ITEM NO: 7

Application No.
18/00160/FUL
Site Address:

4-5 Keepers Coombe Bracknell Berkshire RG12 0TN

Proposal: **Erection of two storey front extensions to both properties, with driveway enlargement to 5 Keepers Coombe.**

SITE PLAN AS PROPOSED @ 1:500

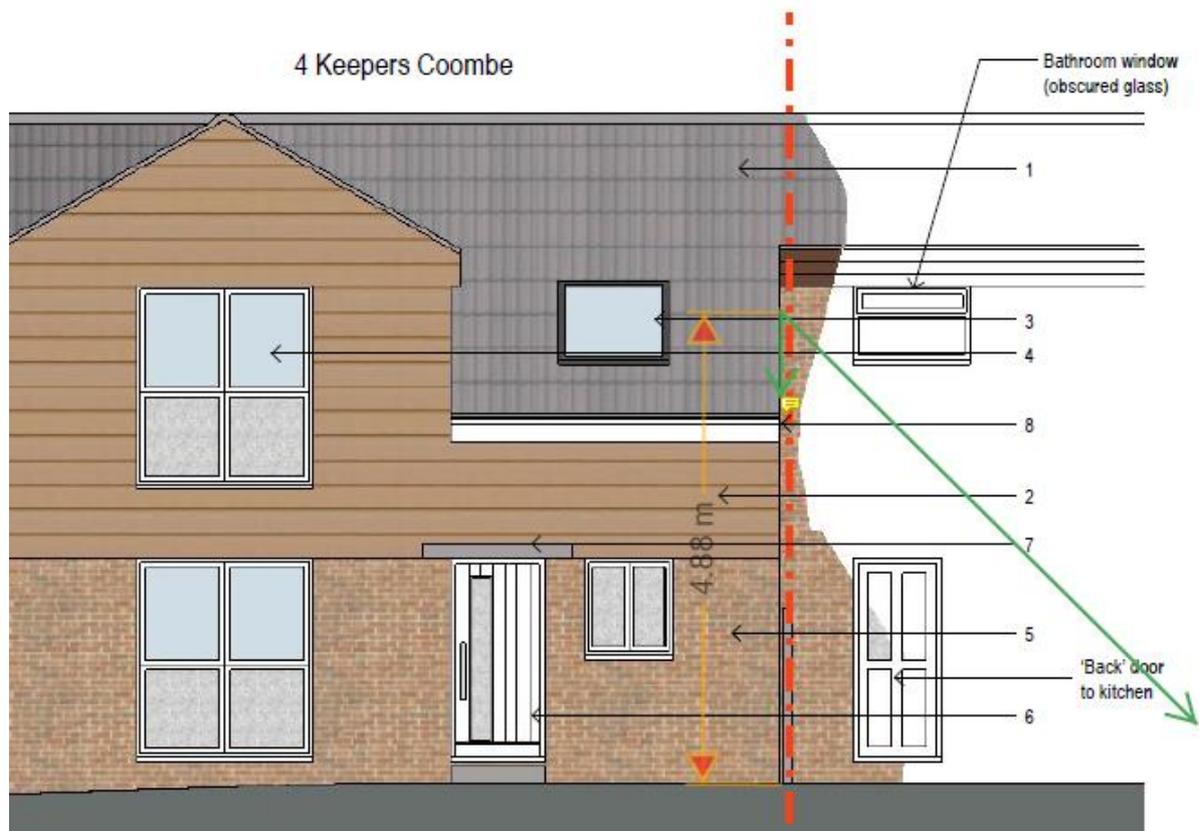
5.4 The depth and position of the proposed extensions can be seen on the following plan:
